Form 3160-5
(June 2019)

SUNDRY NOTICES AND REPORTS ON WELLS
Do not use this form for proposals to drill or to re-enter an abandoned well. Use Form 3160-3 (APD) for such proposals.

8. Well Name and No. ROSS DRAW 17 FED COM/765H

EOG respectfully requests an amendment to our approved APD for this well to reflect the following changes:

Break Test Diagram (Test Joint)

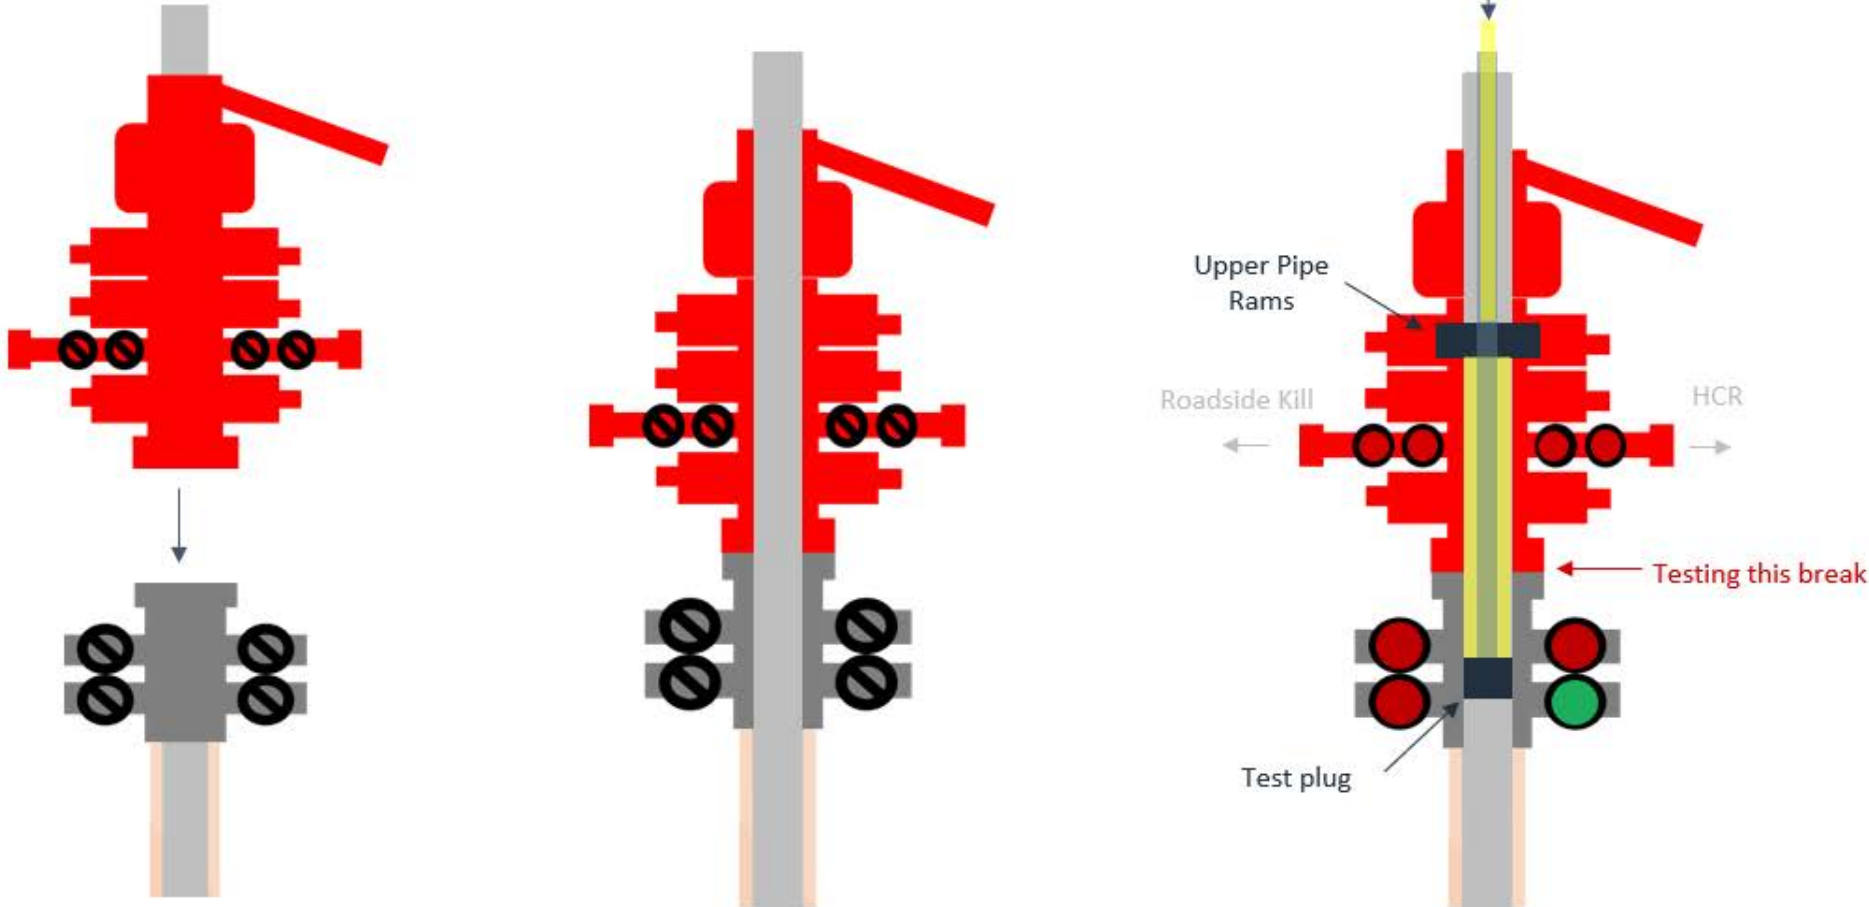
BOPE Break Testing Variance

- BOPE Break Testing is ONLY permitted for 5M BOPE or less. (**Annular preventer must be tested to a minimum of 70% of BOPE working pressure and shall be higher than the MASP**)

Figure 3: Back Yard Rig Up

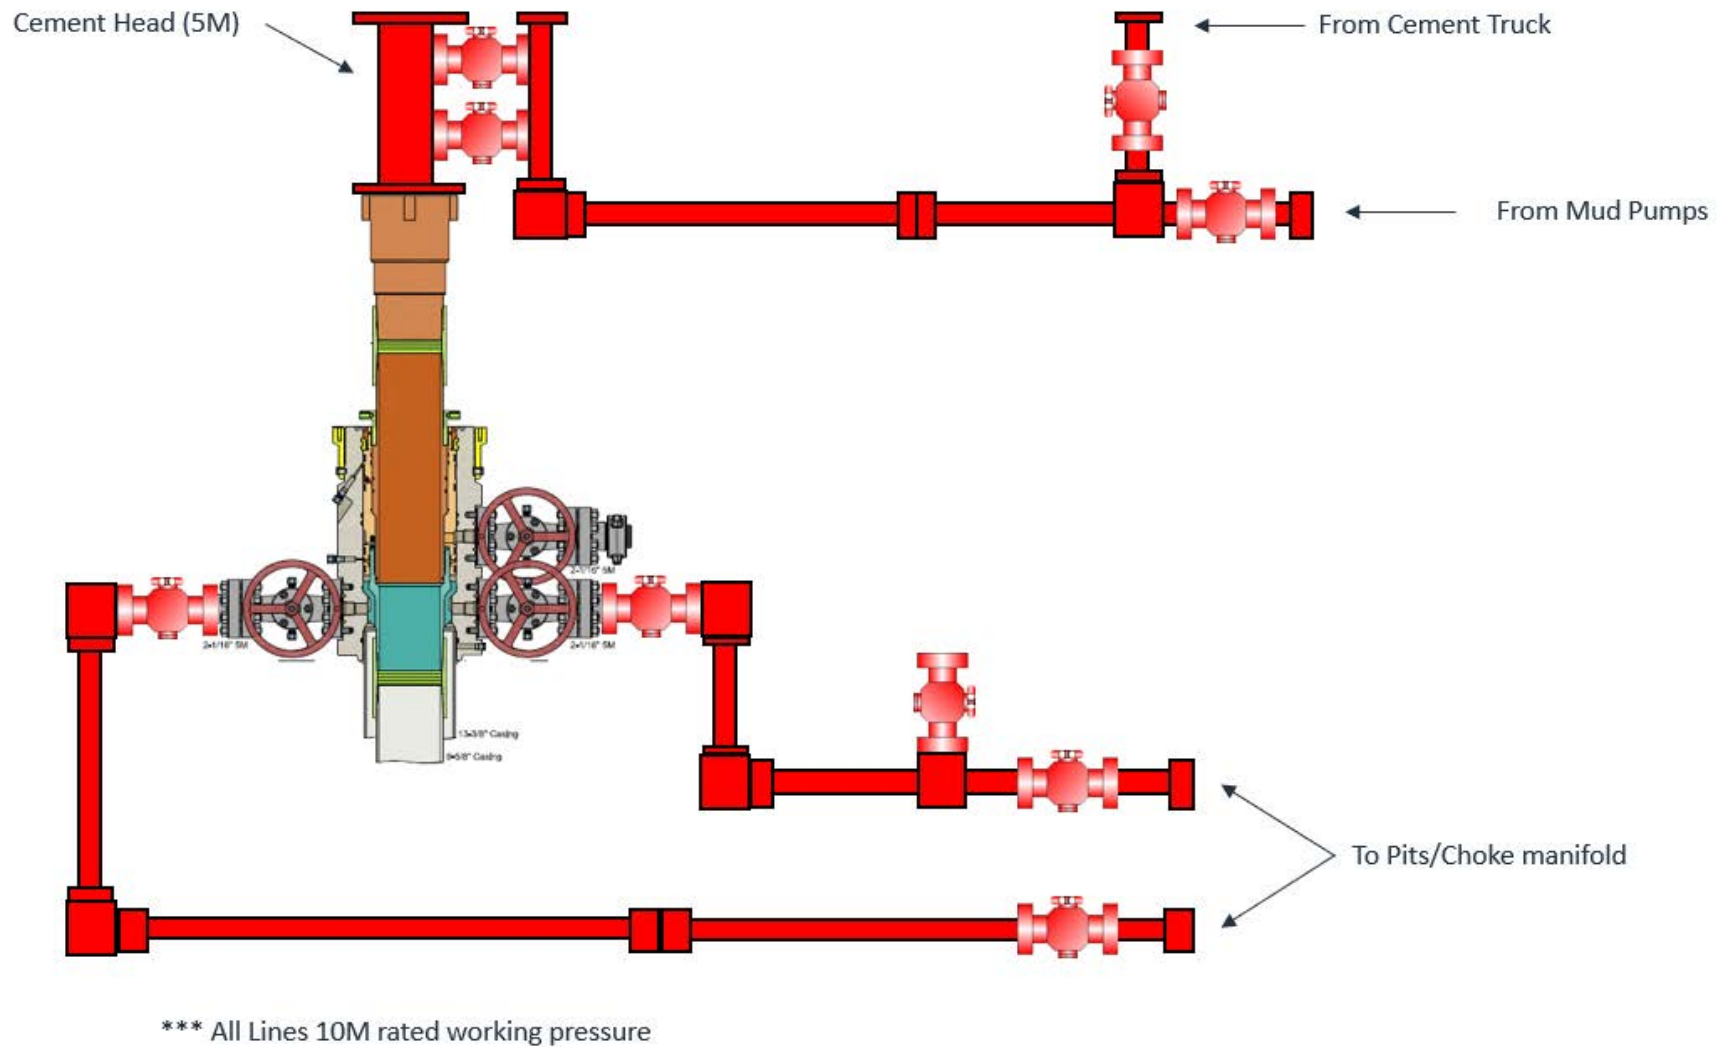
- c. Return line schematics can be seen in Figure 3.
10. Remove TA Plug from the casing.
11. Install offline cement tool.
 - a. Current offline cement tool schematics can be seen in Figure 1 (Cameron) and Figure 2 (Cactus).

Ripple 32 Fed Com #734H/Plan #0.1

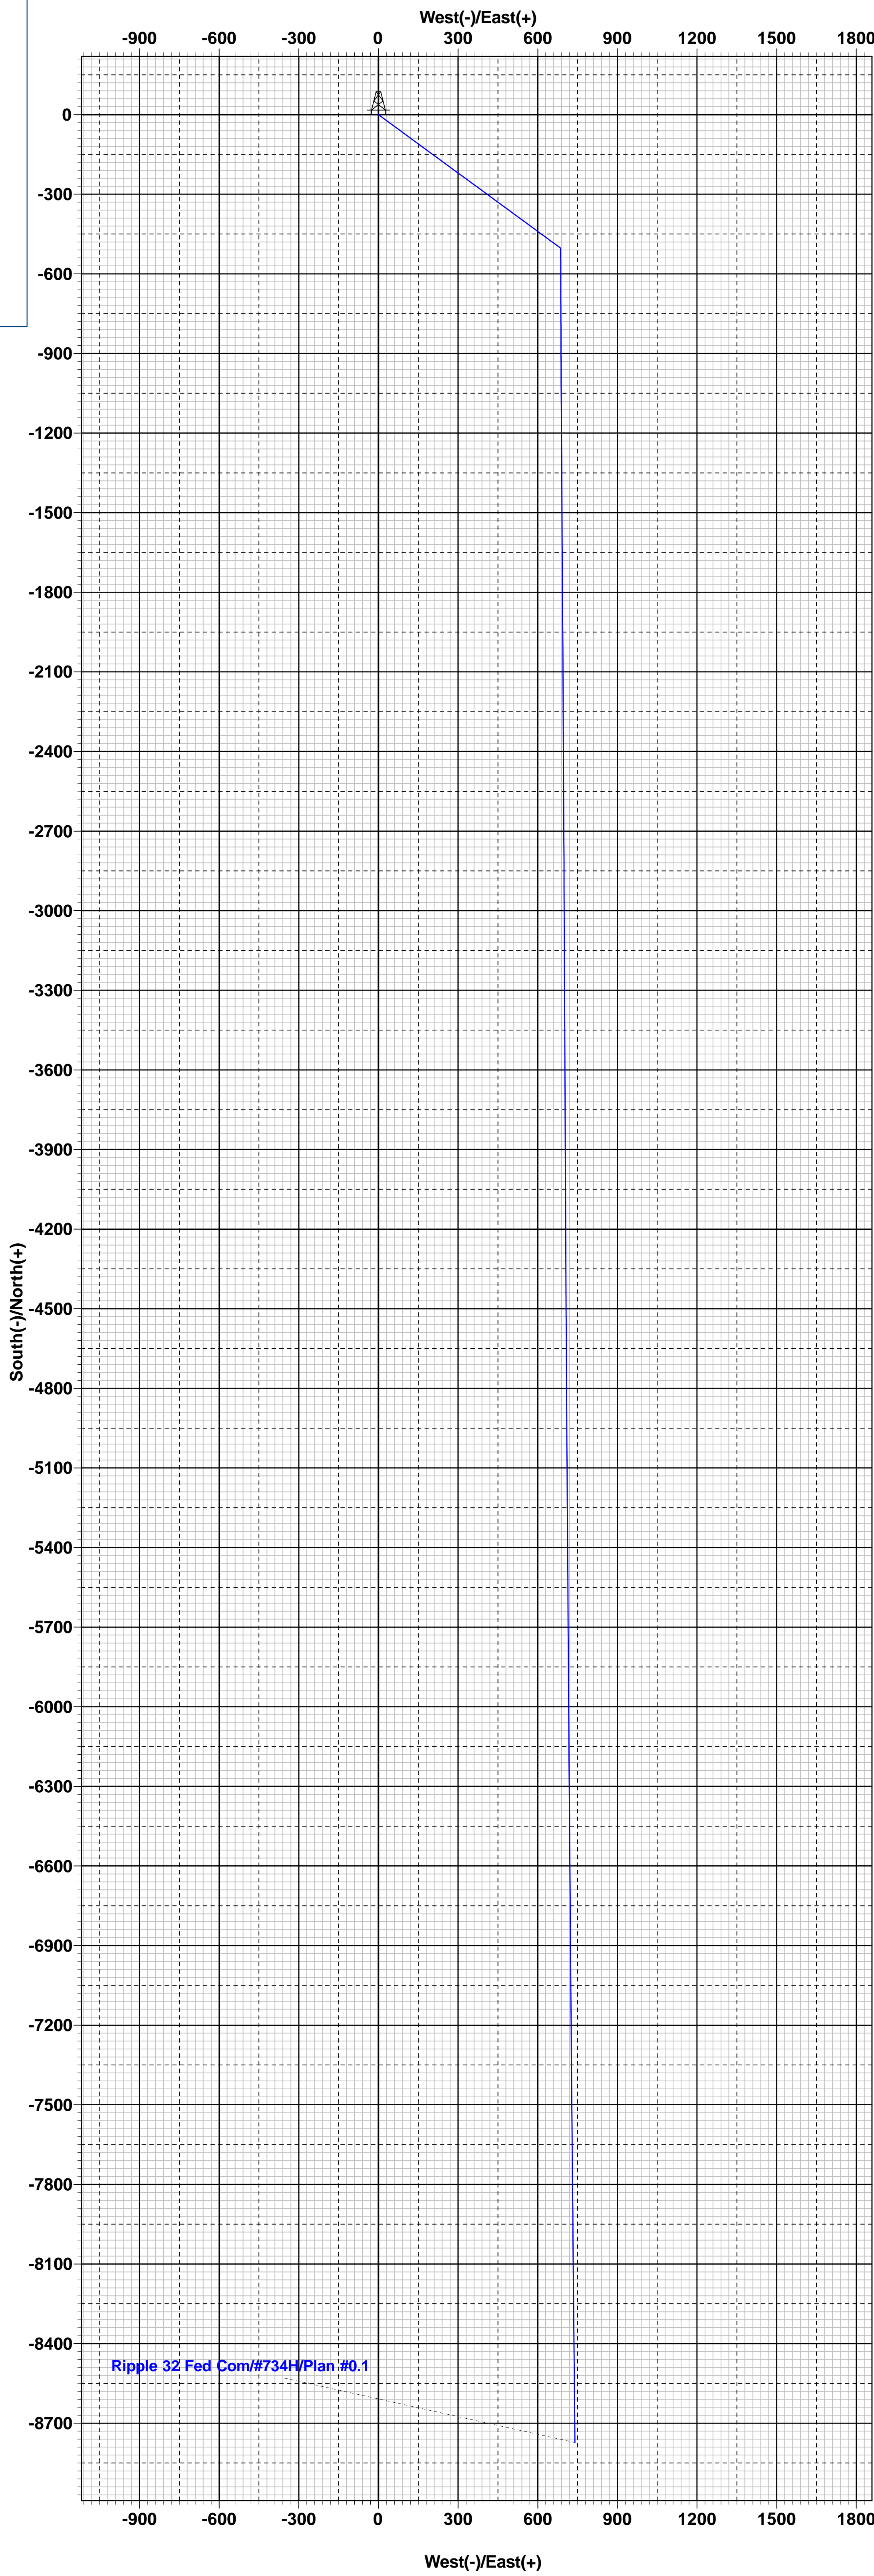
Change BHL from T-26-S, R-31-E, Sec 8, 230' FNL, 1980' FWL, Eddy Co., NM, to T-26-S, R-31-E, Sec 29, 330' FNL, 2430' FWL, Eddy Co., N.M.

0. SHL: TR F / 2205 FNL / 1747 FWL / TWSP: 26S / RANGE: 31E / SECTION: 17 / LAT: 32.04402 / LONG: -103.803346 (TVD: 0 feet, MD: 0 feet)

BHL: TR C / 230 FNL / 1980 FWL / TWSP: 26S / RANGE: 31E / SECTION: 8 / LAT: 32.064092 / LONG: -103.802566 (TVD: 11788 feet, MD: 11811 feet)

BHL: 330' FNL & 2430' FWL, Section 29, T-26-S, R-31-E, Eddy Co., N.M.

Lateral: 19,763' MD, 11,618' TVD
Upper Most Perf:
2332' FSL & 2430' FWL Sec. 17
Lower Most Perf:
330' FNL & 2430' FWL Sec. 29
BH Location: 330' FNL & 2430' FWL
Sec. 29
T-26-S R-31-E
